System General Order #2026-002

Effective 0001 CST, April 8th, 2026

Subject: System General Order #2026 - 002

BRC Timetable and System Special Instructions #7, Effective April 1, 2020

ITEM 11 – BRC SPEED SIGNALS (TTSI Page 74)

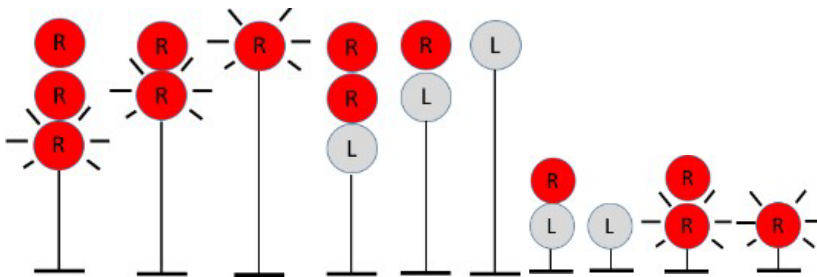
Where RESTRICTING signals are displayed, these will utilize flashing red aspects in accordance with BRC SSI Rule 9.1.3, RESTRICTING.

Where RESTRICTING signals are displayed, these will utilize flashing red aspects in accordance with BRC SSI Rule 9.1.3, RESTRICTING.

9.1.3 RESTRICTING:

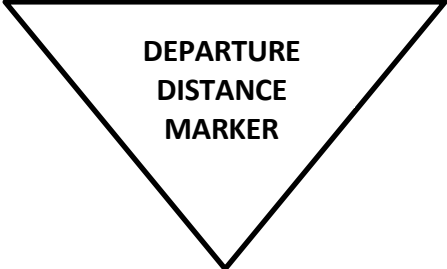
Aspects shown apply when displayed on a signal with, or without, a number plate.

BELT RAILWAY COMPANY OF CHICAGO - ELSDON INDUSTRIAL LEAD LINE MP 0E - MP 1.5E

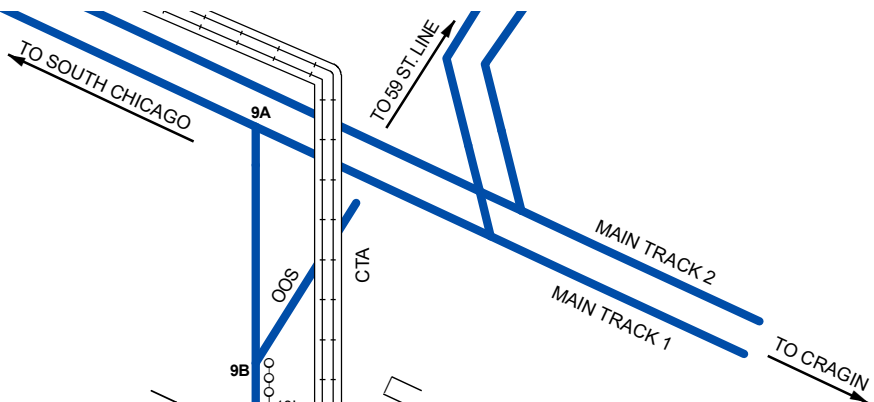
The Elsdon Industrial Lead is Out of Service between 0.0E and MP 1.5E
